**Re: Crown-Indigenous Relations and Northern Affairs Canada's Review of the 2024 Annual Report for Meadowbank and Whale Tail Gold Mine Projects, Type A Water Licence Nos. 2AM-MEA1530 and 2AM-WTP1830.**

## **Technical Review Memorandum**

**Subject:** Crown-Indigenous Relations and Northern Affairs Canada's (CIRNAC's) Review of the 2024 Annual Report for Meadowbank and Whale Tail Gold Mine Projects, Type A Water Licence Nos. 2AM-MEA1530 and 2AM-WTP1830.

Figure 6-1 from Appendix 14 (Whale Tail site)

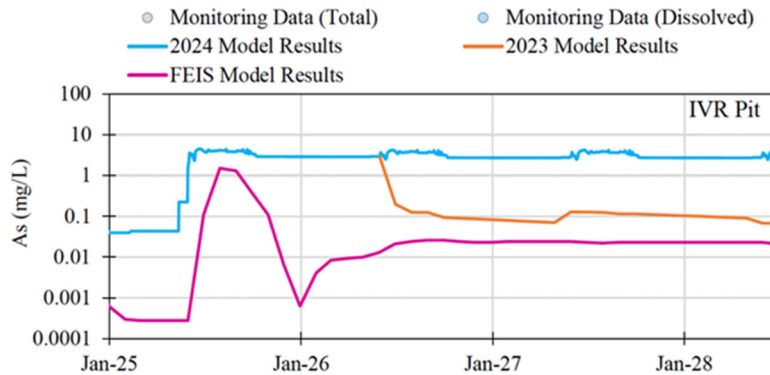
In this case, the figure clearly demonstrates that there has been a wide range of water quality predictions throughout the evolution of the Whale Tail Project. At the right side of the figure, the current 2024 arsenic concentration predictions for the IVR Pit are approximately two orders of magnitude greater (i.e., 100 X) than what was predicted in the 2019 FEIS.

Collectively, the example figures demonstrate that predictions can change significantly over time and that measured concentrations often differ by multiple orders of magnitude relative to predictions. The 2024 Annual Report and supporting documents contain numerous similar variances.

(R-04) CIRNAC recommends that Agnico Eagle perform quantitative sensitivity analyses of their water quality predictions. The analyses should quantify potential variability in all major source terms and associated pathways (e.g., elevated arsenic seepage from pit walls, waste rock storage facilities (WRSFs) and mine areas). CIRNAC acknowledges that some sensitivity analyses have already been performed in prior predictions, but a more comprehensive analysis of all variables is justified. The additional information is necessary to verify Agnico Eagle’s conclusion that their modelling results are conservative and over-predict any potential impacts. Results from past predictions demonstrate that this is not the case.

Figure 10 from the 2024 Annual Report (Meadowbank Site)

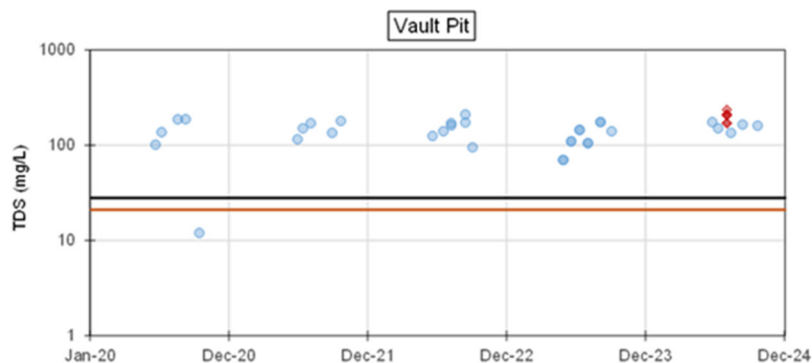
In this case, the figure illustrates that measured TDS concentrations in the Vault Pit are approximately one order of magnitude (i.e., 10x) greater than Agnico Eagle's "poor end" prediction during the original Water Licence application.

Figure 11 from the 2024 Annual Report (Meadowbank Site)

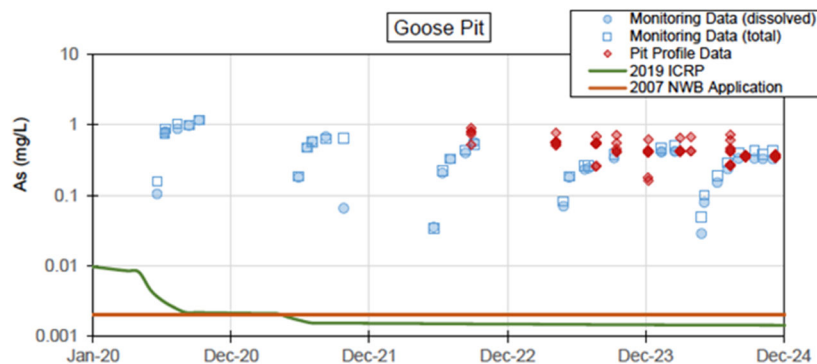
In this case, the figure shows that measured arsenic concentrations in Goose Pit are two orders of magnitude (i.e., 100x) greater than the most recent ICRP water quality predictions from as recently as 2019.

Figure 6-4 From Appendix 14 of the 2024 Annual Report

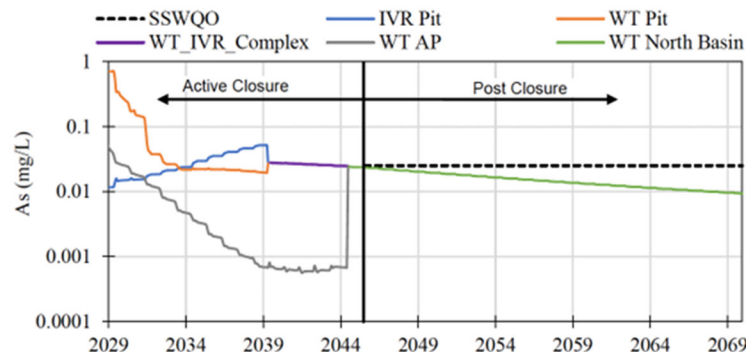
In this instance, arsenic concentrations in Whale Tail Lake are predicted to equal the Site-Specific Water Quality Objective (SSWQO) in 2044. On that basis, Agnico Eagle indicates that it will reconnect the pit lake to the receiving environment, and the post-closure phase will begin immediately afterward. Taking into consideration the uncertainty associated with

model predictions (as noted above), CIRNAC considers it inappropriate to make closure decisions without any “margin of error”. Instead, CIRNAC’s position is that closure decisions should be based on a more conservative set of assumptions regarding future water quality, taking into account the accuracy of past predictions.
